# Product Update Bulletin #6441

**Affected Products:** *All FieldBlock FNT, FNP, FNS models, and 6-point Drop Connectors (DR465036A, DR465037A, DR465038A, DR465039A, DR465040A, DR465041A, DR465042A, DR465043A, DR465044A, DR465045A, DR465046A, DR465047A)*

## Design Change Notification

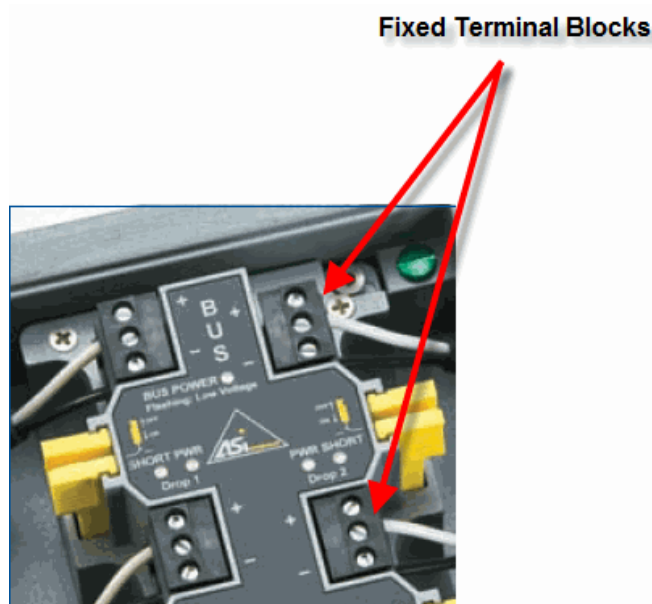
In preparation for hazardous location approvals for the FieldLink FN and 6-Drop din rail mount drop connectors, we have changed from pluggable terminals blocks to fixed terminal blocks. The blocks look the same but have been fastened in place.

This was done so that these products meet the standards for Class 1, Division 2 and ATEX/IECEX hazardous location approvals.
